PLAN REVIEW COMMENTS FOR DP-09-22-017188

Town of Bluffton

BUCK ISLAND/SIMMONSVILLE

SITE DEVELOPMENT PLANS
FOR
CROWNE AT BUCK ISLAND
APARTMENTS
BLUFFTON, SOUTH CAROLINA

COMMON OPEN SPACE CALCULATION			
DESCRIPTION	AREA	REQUIRED %	%
TOTAL SITE AREA	10.11 AC.		
TOTAL OPEN SPACE %	± 1.31 AC.	10%	± 13%

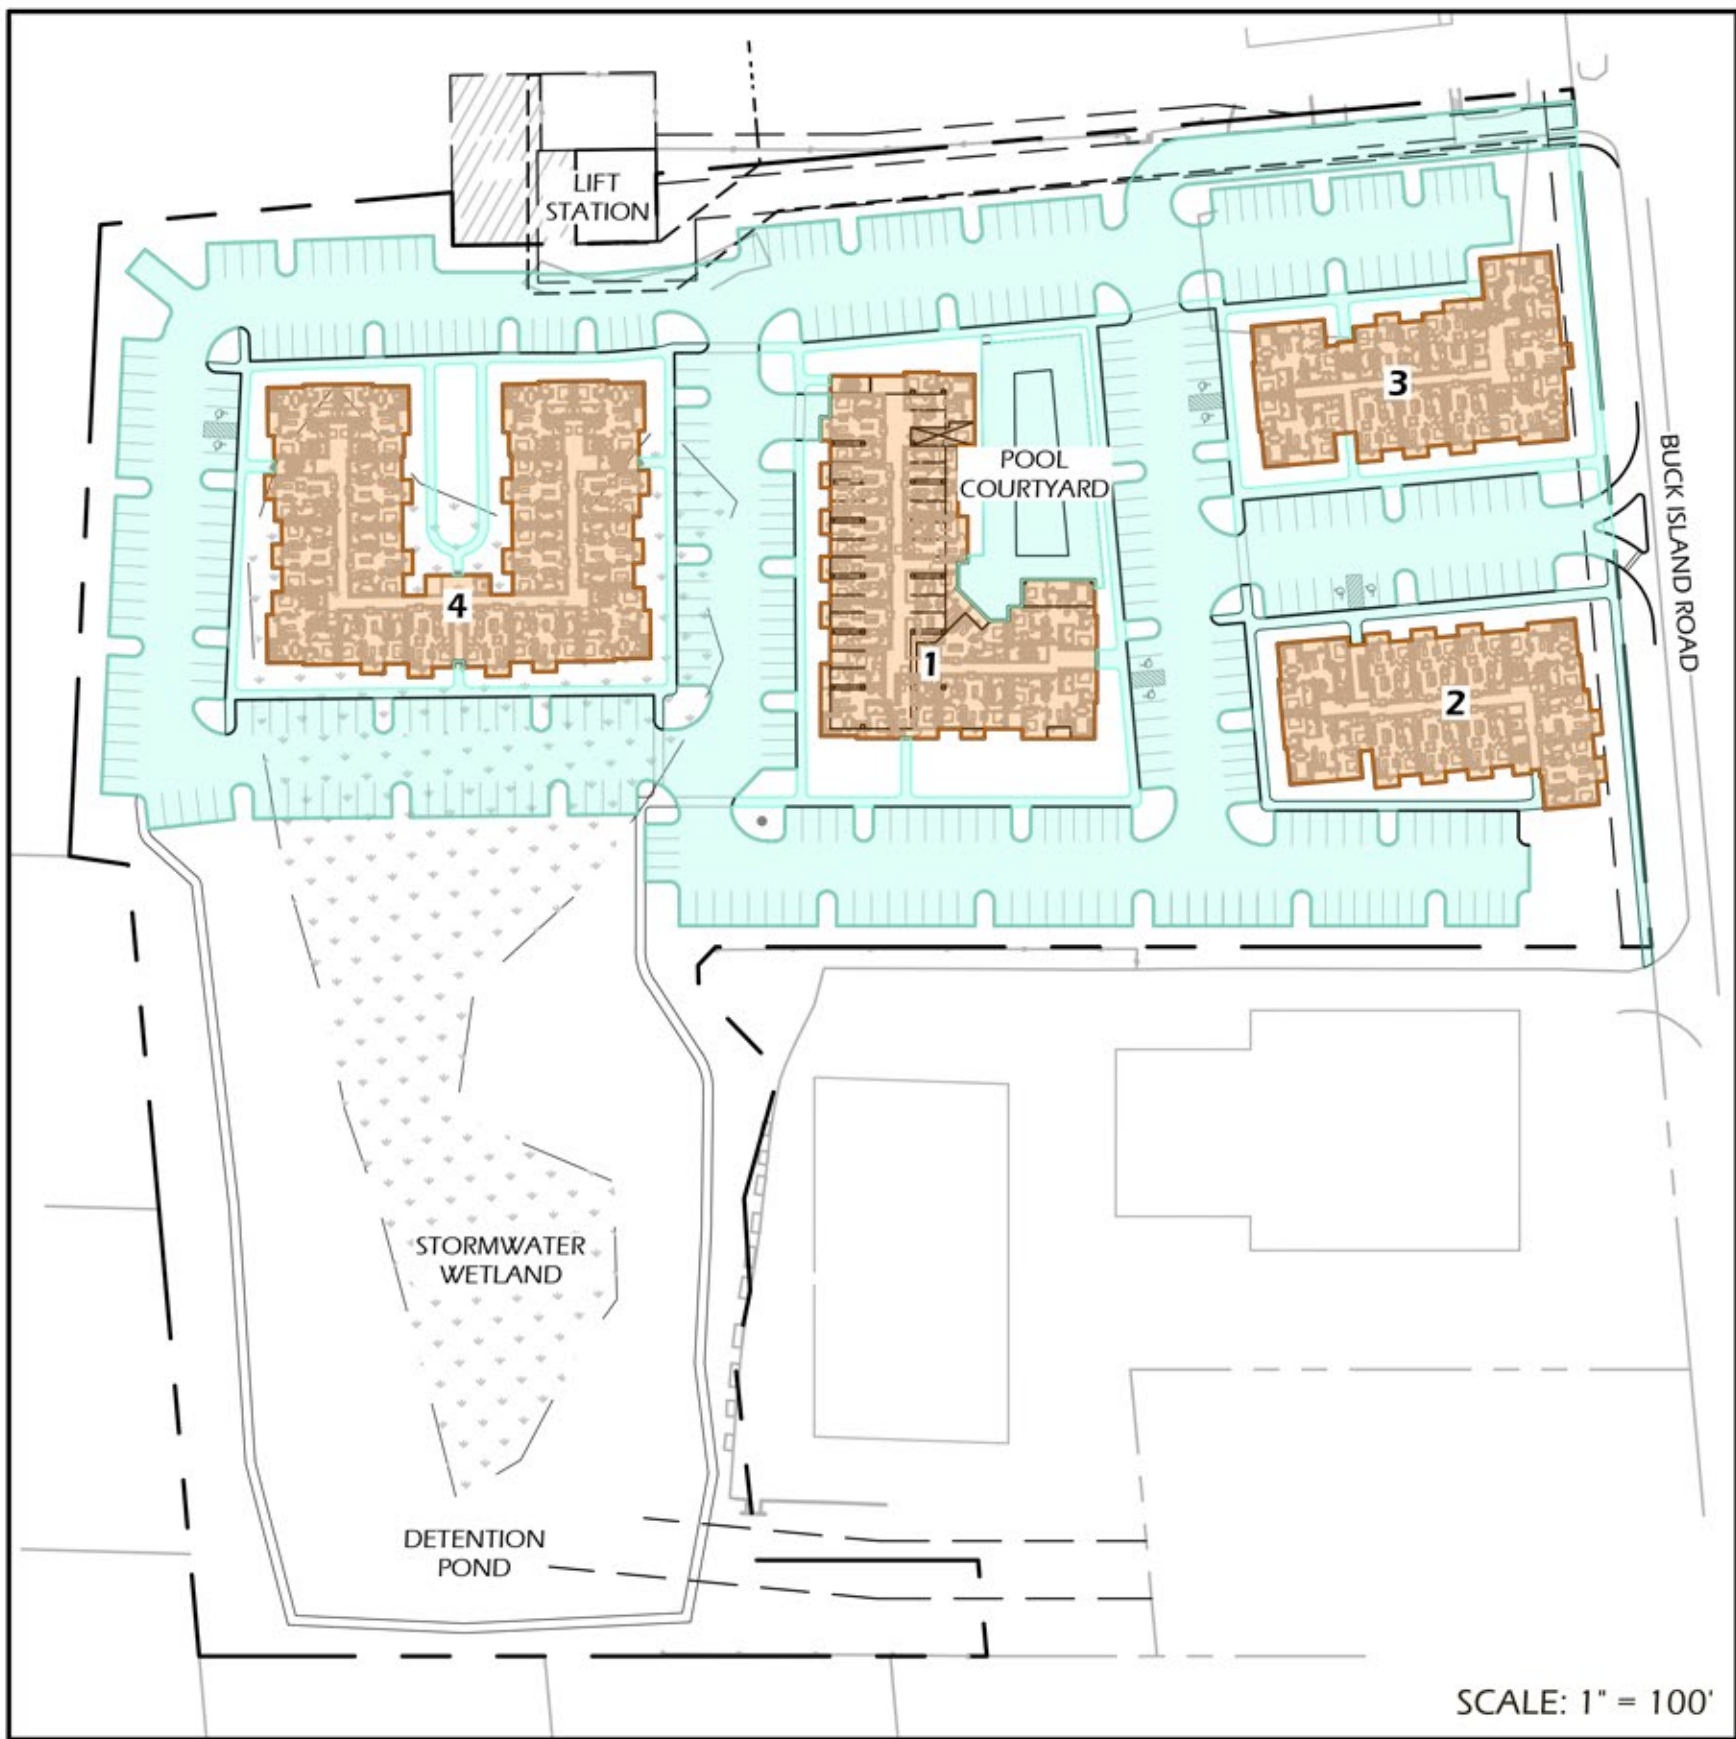
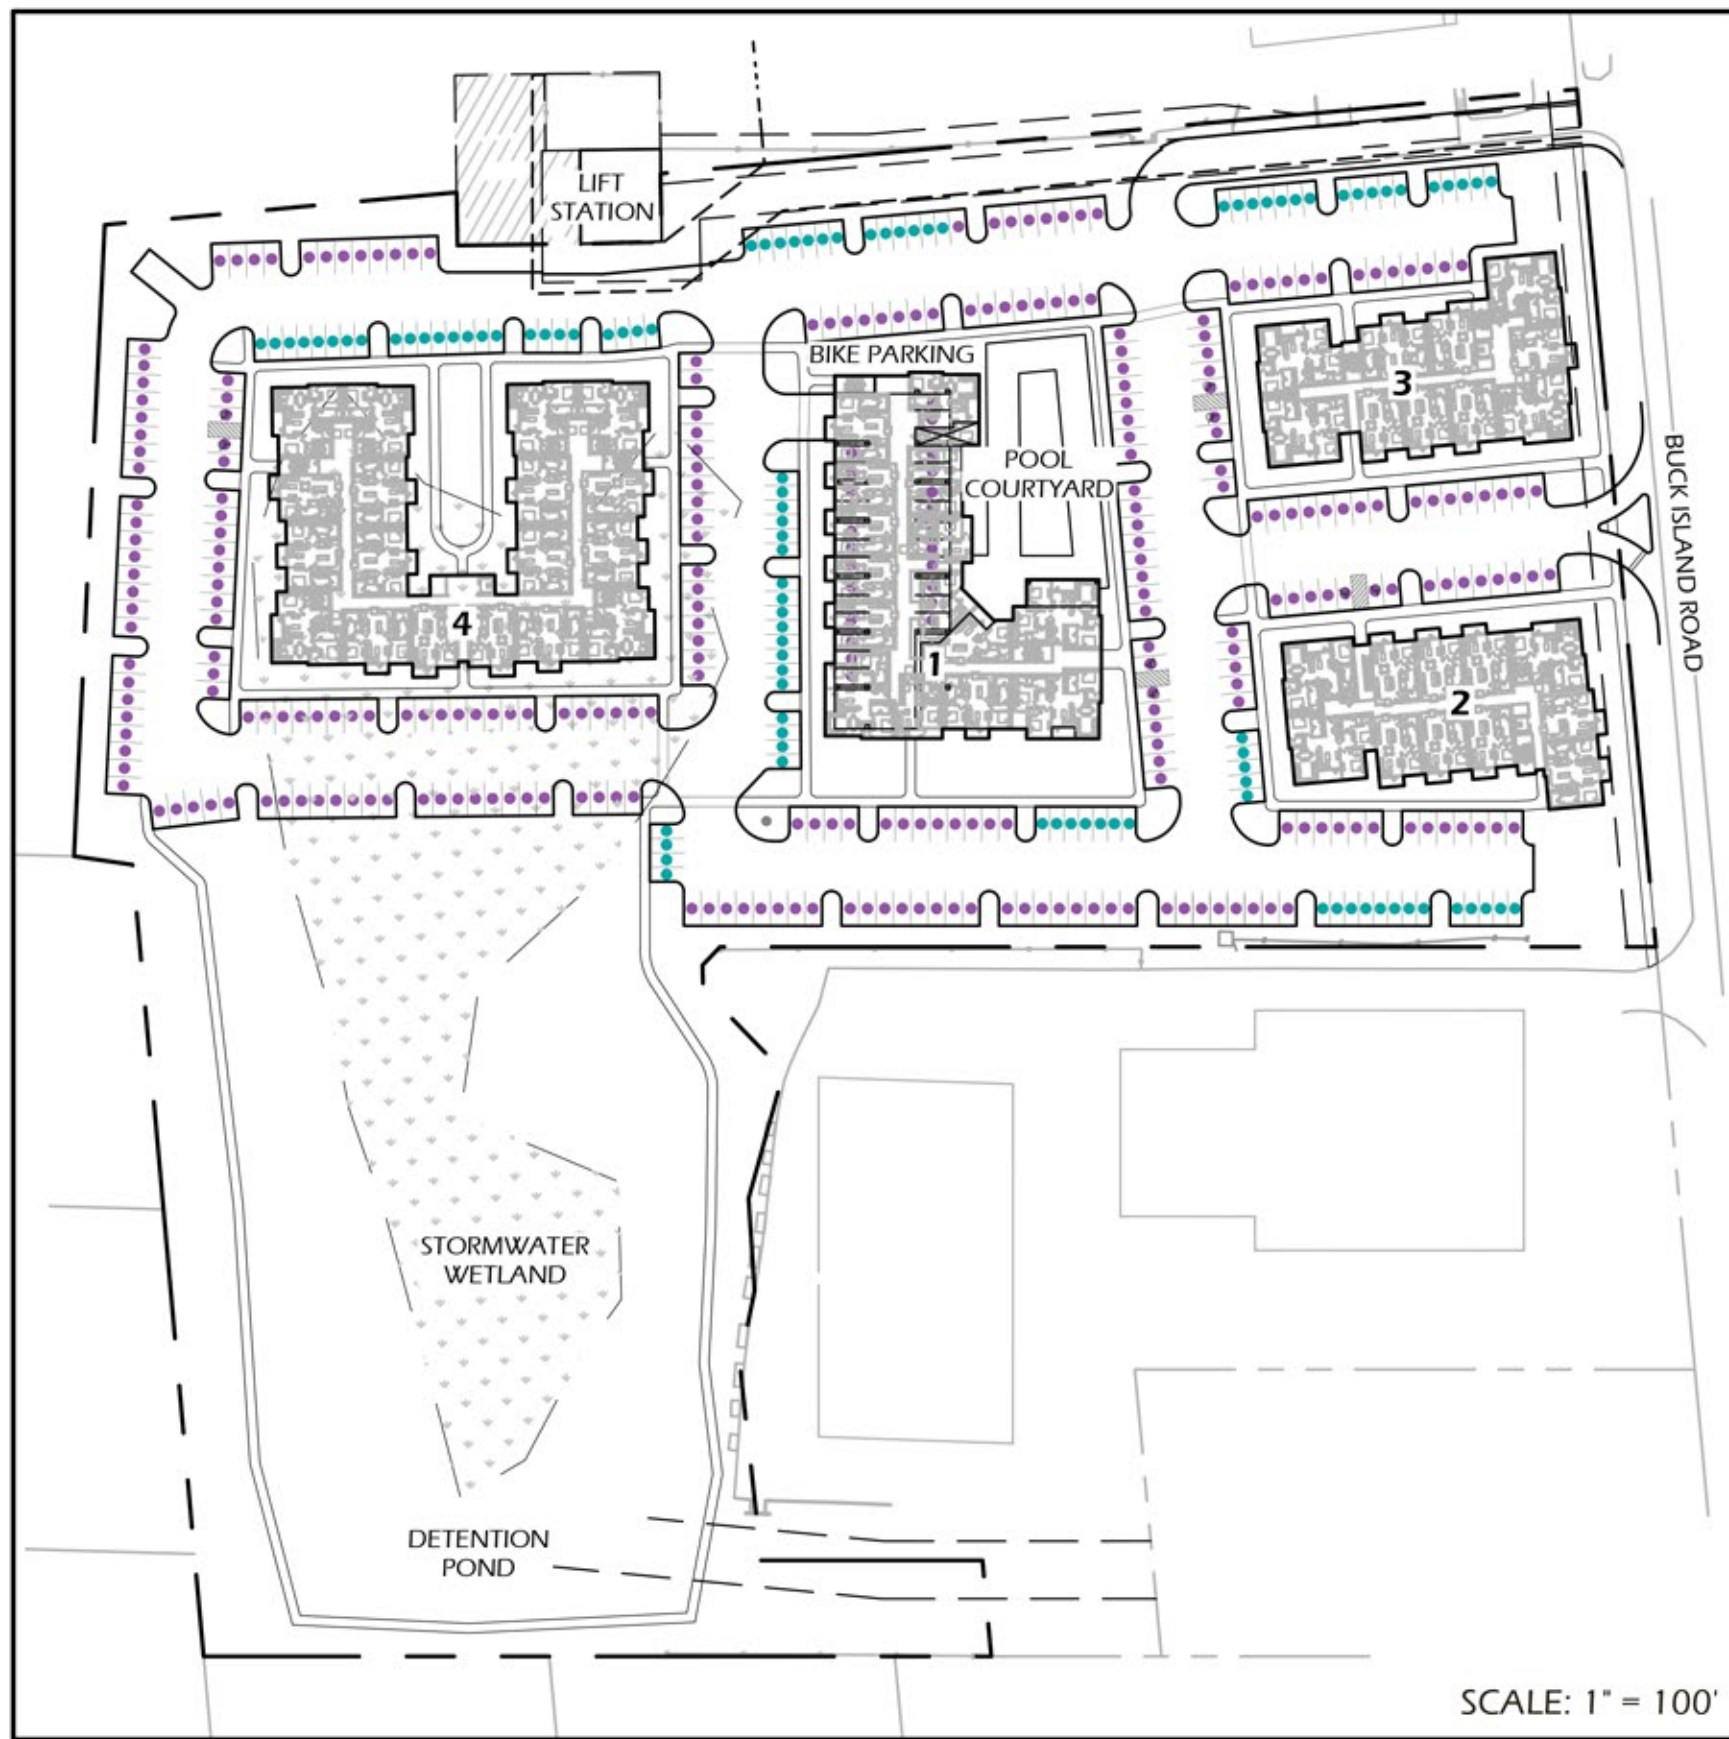
12. Wheel stops shall be provided in all parking facilities without curbing (UDO Section 5.11.4.A.4).
13. Demonstrate how the common open space identified on Sheet L12 meets the common open space requirements of UDO Section 5.6.4.
